Information Requests

Whale Tail Pit Expansion Project Proposal

February 21, 2019

Figure 6-I-2 from Appendix 6-I of the FEIS for the Expansion Project

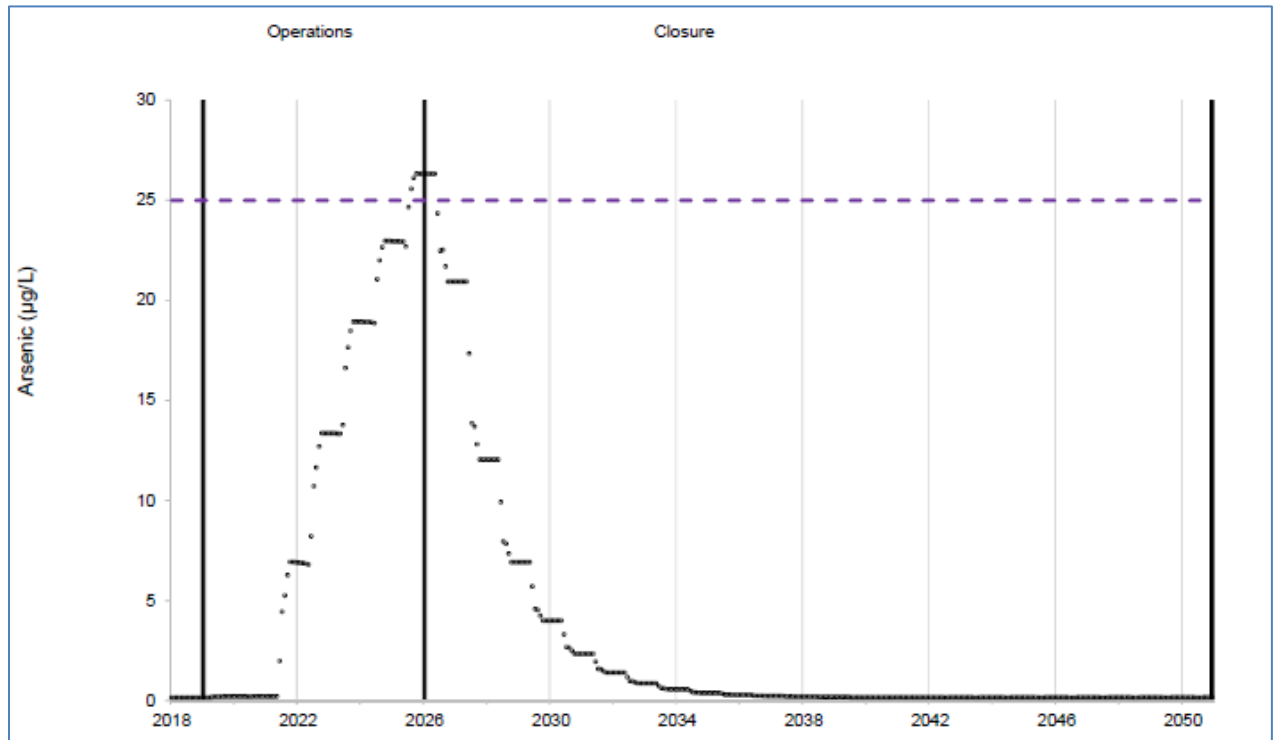
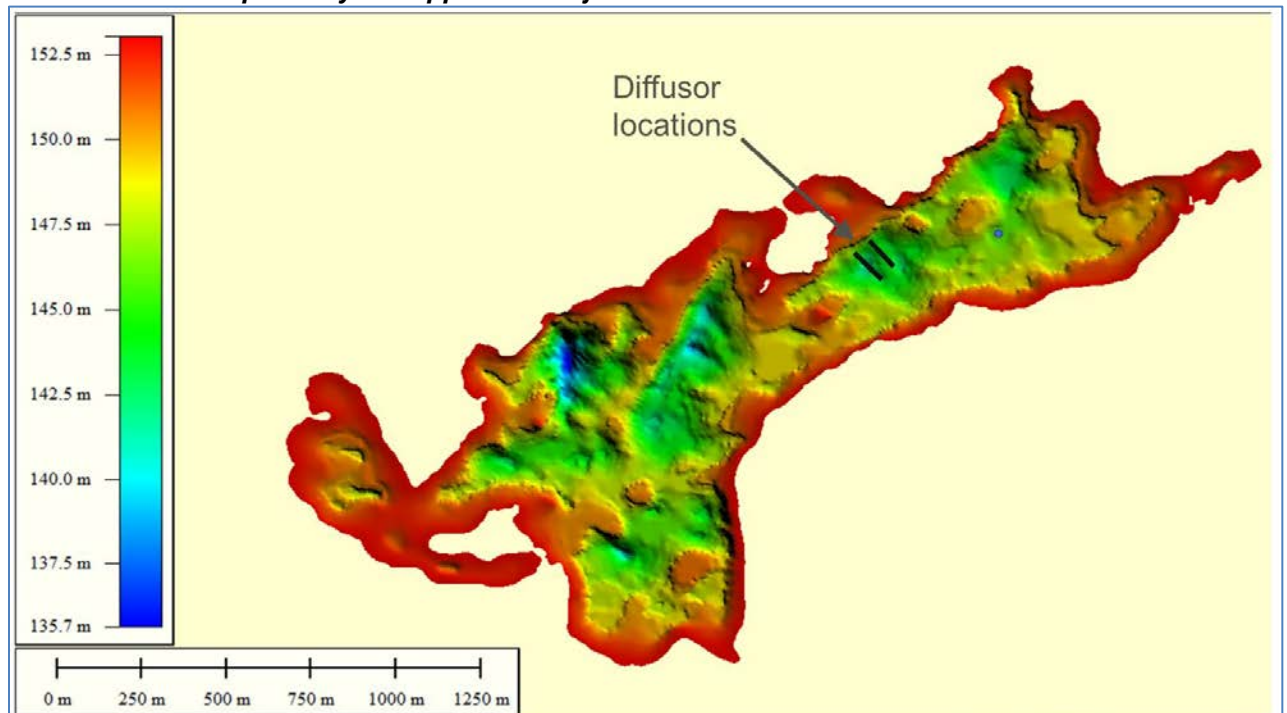
Information Request Number	CIRNAC IR#: 5
To	Proponent – Agnico Eagle
Subject	Confirmation of Requirements and Impacts for New Water Discharge and Intake Points
Reference(s)	FEIS FEIS Vol. 6, Freshwater Environment APPENDIX 6-H Addendum Mine Site and Downstream Receiving Water Quality Predictions APPENDIX 6-I Addendum Water Quality Prediction Summary
Issue/Concern	<p><u>New Discharge Point to the South Basin of Whale Tail Lake</u></p> <p>The FEIS states that AEM will require an additional discharge point into the South Basin of Whale Tail Lake. As shown in the following figure (Fig. 6-I-2 from Appendix 6-I, reproduced below), arsenic concentrations are predicted to rapidly increase until they exceed the SSWQO by the end of the brief operations phase. Based on this trend, it appears there is no “margin of error” for discharges to the basin. Specifically, higher than anticipated loading rates and/or a longer operations phase could result in arsenic concentrations that are well above the SSWQO.</p> <p>The FEIS does not present the rationale for discharging to this fish-bearing lake and alternative discharge scenarios are not evaluated. For example, the document does not describe why the approved discharge location in Mammoth Lake is insufficient to meet the needs of the Expansion Project. Similarly, the FEIS does not identify alternative approaches to ensure arsenic concentrations in Whale Tail Lake are kept as low as reasonably achievable (e.g., through improved effluent quality).</p> <p><u>Modified Mammoth Lake Discharges</u></p> <p>Throughout the environmental assessment and regulatory processes for the Approved Project there was an evolution in the proposed location and configuration of effluent discharges to Mammoth Lake. During a presentation to CIRNAC on July 26th, 2018 to discuss the (now) Approved Project, AEM indicated two diffusers would be required to meet the applicable water quality criteria. The locations of the two diffusers were identified in a figure which is reproduced below.</p> <p>With regard to the Expansion Project, the FEIS now indicates that only one diffuser is required in Mammoth Lake and that it will be in a different location than noted above. The location of the revised discharge location for Mammoth Lake is shown in Figure 1.2-1 of the Expansion Project FEIS (reproduced below). No information is provided to explain the revised diffuser requirements for Mammoth Lake.</p> <p><u>Alternative Discharges</u></p> <p>The FEIS states: “Any water requiring treatment will be pumped to the water treatment plant(s) prior to discharge through the diffuser in Mammoth Lake or through a diffuser in Whale Tail Lake (South Basin) or other alternatives.”. It also indicates: “Agnico Eagle may require an additional discharge point(s)”. However, the FEIS provides no information on alternative discharge locations. On this basis, CIRNAC assumes AEM is not proposing any other discharge locations with the current application.</p>

<p><u>Waste Stream Mixing</u></p> <p>Appendix 6-H for the Expansion Project indicates that effluent from the water treatment plant will be mixed with effluent from the sewage treatment plant to lower the concentration of most constituents. Based on CIRNAC's understanding, this is not within the scope of the Approved Project. The FEIS package does not describe why the change is required, nor does it explain the environmental implications of the change.</p> <p><u>Mammoth Lake Emulsion Plant Intake</u></p> <p>The FEIS indicates the Expansion Project will require a new water intake from Mammoth Lake to supply an Emulsion Plant. While the volumetric requirements of this intake are minor, no information is presented to justify why the new facility is required (i.e., as opposed to using water from the Nemo Lake intake).</p>
Information Request	<p>CIRNAC recommends that the following additional information be provided prior to the Technical Review phase. The information is necessary to understand the scope of the proposed project, why any changes are justified and to assess any incremental environmental impacts.</p> <p>5a) AEM should justify all proposed changes to water intake/discharge infrastructure and operational practices (e.g., effluent mixing), emphasizing why the requirements have changed since the Approved Project.</p> <p>5b) AEM should explicitly identify and describe the environmental impacts associated with any incremental chemical loadings caused by the Expansion Project. In addition, AEM should specify the water quality implications to surface water receivers if arsenic loading rates are higher than currently predicted and/or the duration of discharge is longer than planned. In situations where there are potential exceedances of applicable water quality criteria, potential mitigation measures should be evaluated (e.g., more stringent effluent criteria to reduce the probability and severity of impacts to surface water receivers).</p> <p>5c) AEM should confirm it is not proposing alternate water intake or discharges, other than those described in detail and explicitly assessed in the FEIS.</p>

Note: The following three figures are provided to support the discussion presented in CIRNAC Information Request #5.

Figure provided by AEM to CIRNAC on July 26th, 2018 identifying two effluent diffusers in Mammoth Lake required by the Approved Project

Figure 1.2-1 of the Expansion Project FEIS identifying only one diffuser in Mammoth Lake at a different location
